# HEARING REPORT

To:	Paul Wanders   Vaishali Sankar
For:	Kaipara District Council   Northland Transport Alliance
From:	Rachel Gasson, Leo Hills
Date:	10 April 2024
Subject:	Private Plan Change 84 – Mangawhai Hills, Mangawhai
Commute Reference:	J002652 Mangawhai Hills PC Hearing Report 240410

**Figure 5-1: Structure Plan and Proposed Plan Change Area**

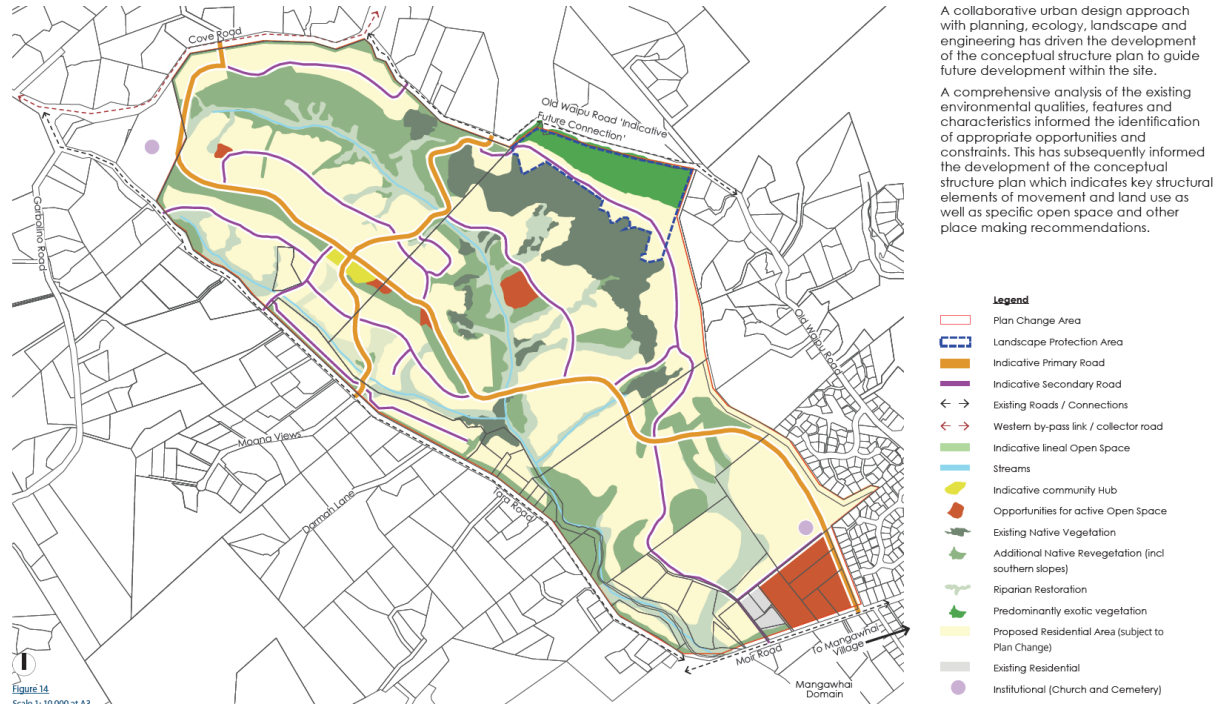
The primary roads in the structure plan dissect the site into quadrants with one road providing a northwest-southeast connection and the other providing a south-west-northeast connection. These primary roads intersect with Moir Street, Cove Road, Tara Road, and Mangawhai Central (via Old Waipu Road North). We support the principle of this roading network.

The TPC ITA has assumed approximately 70% of vehicle movements will be to Mangawhai via either Moir Street or the Mangawhai Central Future Connection with 15% headed North Via Cove Road and 15% Headed west via Garbolino Road or the Kaiwaka Mangawhai Road.<sup>1</sup> We understand that the primary road connections to Moir Street and Mangawhai Central require the agreement of third party land owners, and therefore we are of the opinion that the timing and ability to implement these connections is uncertain. Without these connections, the effect of the Plan Change on surrounding intersections will be greater than that which has been assessed.

While these connections are beneficial in providing network connectivity, there is some capacity in the network. Should the Moir Street/Mangawhai Central connections not be provided in the short-medium term, with some upgrades it is likely that nearby intersections could operate acceptably with the majority of the Plan Change in place, however there is no assessment of this included in the applicants Transport Assessment. To address this it is recommended that further sensitivity testing be undertaken by the applicant prior to the

hearing to assess the effects on the roading network in the event that the roading connection to Moir Street through the South of the site and to Mangawhai Central through the East of the site is not able to be provided. This will provide more information on the ability of the transportation network to cope with the additional vehicle movements and any upgrades, staging rules or further assessment criteria that are needed.

**We recommend further sensitivity testing is undertaken by the applicant prior to the hearing to assess the traffic effects of the plan change should the Moir Street and Mangawhai Central primary road connections not be constructed. This information will help inform any upgrades, staging rules or further assessment criteria that may be needed.**
